AMD-K6[®]-2

Processor Revision Guide

Model 8

Publication # 21641 Rev: F Amendment/ 0 Issue Date: June 1999
--

Figure 1. AMD-K6[®]-2 Processor Assertion of HLDA Due to Simultaneous \overline{BOFF} /HOLD Assertion

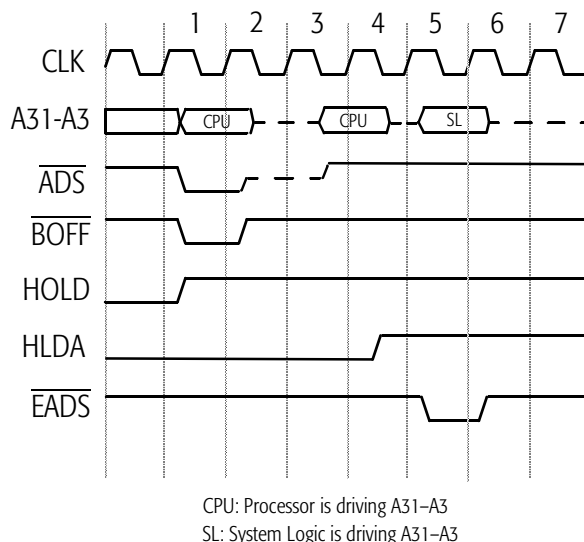
Non-conformance. If $\overline{\text{BOFF}}$ and HOLD are sampled asserted on the same clock edge that negates $\overline{\text{ADS}}$, the processor asserts HLDA two clock edges after HOLD is sampled asserted.

- If the system logic asserts $\overline{\text{BOFF}}$ for a duration of one clock, anticipates the assertion of HLDA in clock 3 (see Figure 1)—which is the normal specified operation—and drives the address bus and $\overline{\text{EADS}}$ for an inquire cycle in clock 3, then the processor will not sample $\overline{\text{EADS}}$ asserted. In addition, address bus contention will occur in clock 3.

- If the system logic asserts $\overline{\text{BOFF}}$ for a duration of two clocks, anticipates the assertion of HLDA in clock 3, and drives the address bus and $\overline{\text{EADS}}$ for an inquire cycle in clock 3, then the processor will not sample $\overline{\text{EADS}}$ asserted. (No address bus contention occurs in this case.)

- If the system logic asserts $\overline{\text{BOFF}}$ for a duration of one clock, anticipates the assertion of HLDA in clock 3, and drives the address bus and $\overline{\text{EADS}}$ for an inquire cycle in clock 4, then address bus contention may occur in clock 4. (The processor will sample $\overline{\text{EADS}}$ asserted in this case.)

If the processor does not sample $\overline{\text{EADS}}$ asserted during an inquire cycle, cache/memory incoherency will occur. Address bus contention can affect the reliability of the processor and the system logic.

Suggested Workaround. The system logic must sample the assertion of HLDA before asserting $\overline{\text{EADS}}$ and driving the address bus for an inquire cycle—as shown in clock 5 of Figure 1.

Resolution Status. AMD has determined that all Socket7 and Super7[™] chipsets operate as described in the aforementioned suggested workaround. Therefore, AMD has decided to defer the resolution of this erratum until deemed necessary.
